INITIAL FIRE SAFETY INSPECTION REPORT

Factory Name: Denim Asia Limited (Extension Building)

Date: 21.09.2021

Table-1:Findings & Recommendations for washing building

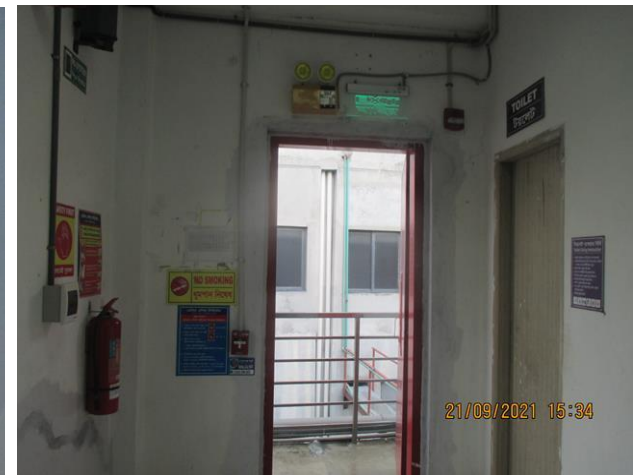
F-1	Fire Rated Construction	Exit Enclosures are not properly fire separated from other occupancy on each floor by fire rated construction. Location: Washing building	Provide minimum 1-hr fire rated separation exit enclosure. Provide minimum 0.75-hr fire rated doors and seal all unprotected openings and penetration by 1-hr fire rated barrier construction to separate the exit stairs from work areas and other building spaces on all floor levels. The clearance under the bottom of a fire door shall be a maximum of 19mm. Ensure that the fire doors are self-closing and positive latching and that they are provided with fire exit (panic) hardware where serving production floors. If fire doors are required to be held open for functional reasons, provide automatic closing devices tied to the fire alarm system.	Within 3 months
